# Cessna 182 Skylane™ ARF
INSTRUCTION MANUAL CORRECTION

Replace step 2, on page 9 in the instruction manual with this step:

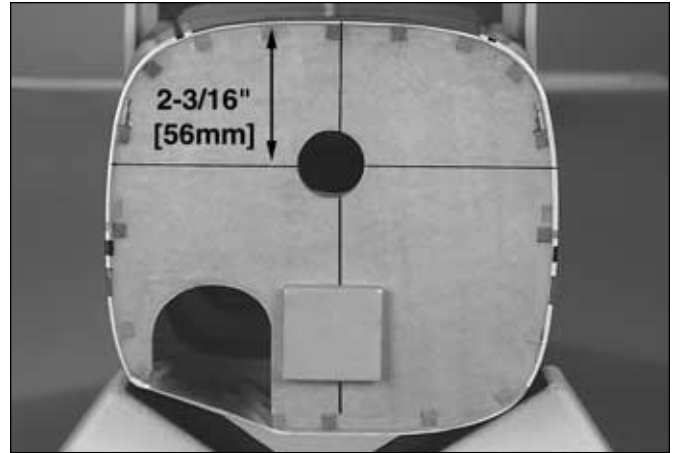
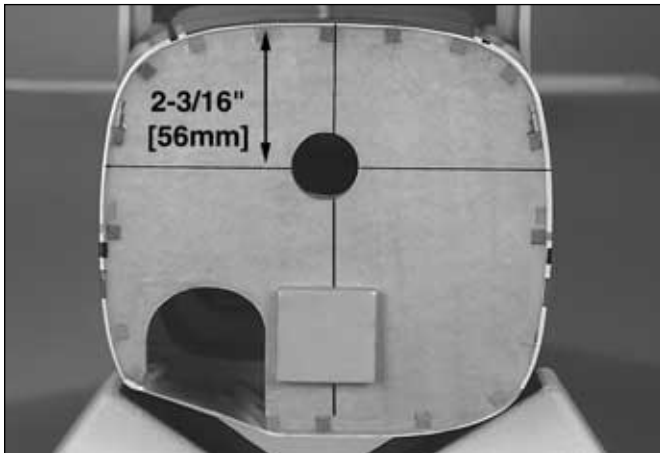
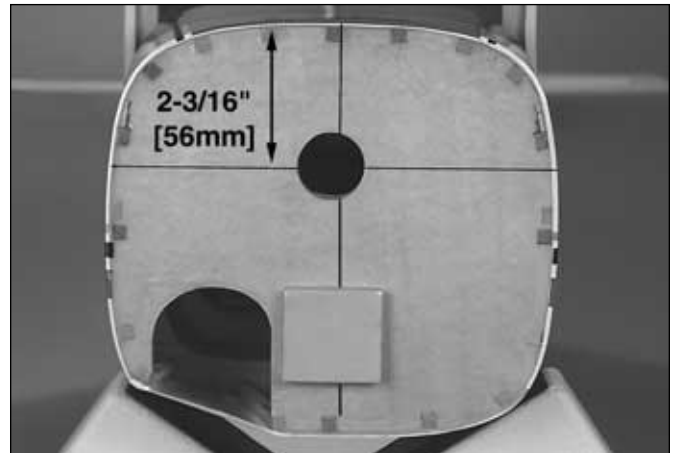
❑ 2. Draw a **horizontal** line on the firewall 2-3/16" [56mm] from the top of the fuselage. Draw a **vertical** line on the firewall along the left side of the top and

bottom stringers as shown in the photo.
